Re: [East 5th Street Rail and Trail Improvements–Navasota Street to East Seventh Street](#)

Thank you for the opportunity to provide feedback on the 30% design and first public input opportunity for the East 5th Street Rail and Trail Improvements–Navasota Street to East Seventh Street project.

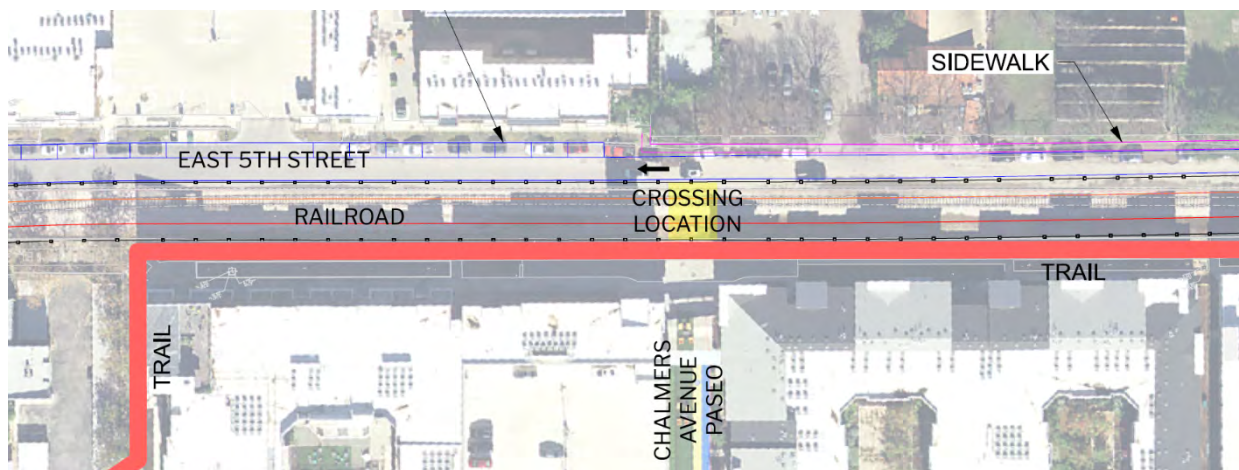
Our primary request is to widen [the paseo](#) that is immediately south of the railroad, heading east from Comal Street, and adjacent to Saltillo Lofts. See “paseo” in the schematic image below for more context. We ask that the west end of the paseo be widened to match the width at its midpoint between Comal and Concho Sts. The staff proposal not only doesn’t widen the paseo, but actually narrows the paseo.

The essential adjustment is to move the railroad and Plaza Saltillo Station platforms to the north by roughly 15' so that the rail tracks can continue east across Comal St. further north, providing more space for the paseo. This can be accomplished through one or more of the following:

- Narrow the East 5th Street right-of-way between Comal St. and Onion St., i.e. the travelway just north of the new Plaza Saltillo Station northern platform. This can provide the minimal

width needed for fire access, and be outfitted as a shared street for the time being. As the properties to its north redevelop, the right-of-way can be reconsidered, and new space will likely be available to provide a sidewalk. This may also require some other minor adjustments at Comal St., e.g. providing a raised crosswalk across 5th St.

- Alternatively, this block of 5th St. could be closed to the public, and a cul-de-sac turnaround created at Onion St. in order to provide access to 5th St. from Navasota St.
- Additional alternatives to reduce the need for width on this section of 5th St. are possible.
- Minor adjustments can be made to rail and other transportation parameters in order to provide small portions of space that collectively provide enough additional space for the paseo. This initial project proposal likely includes many ideal or preferred widths/lengths for the rail and roadway accommodations, but many of these can be reduced to minimum or acceptable dimensions in order to provide adequate paseo width for the Red Line Trail / Parkway.
- Moving [the retaining wall](#) along the north edge of East 5th Street would provide additional right-of-way for East 5th Street.

We ask that the project include an at-grade ped/bike crossing of the railroad [at or near the Chalmers Avenue paseo](#). This would provide a sanctioned crossing where many Austinites and CapMetro transit users have created unsanctioned desired paths through or over the existing fence. See “crossing location” in the schematics image below for more context.
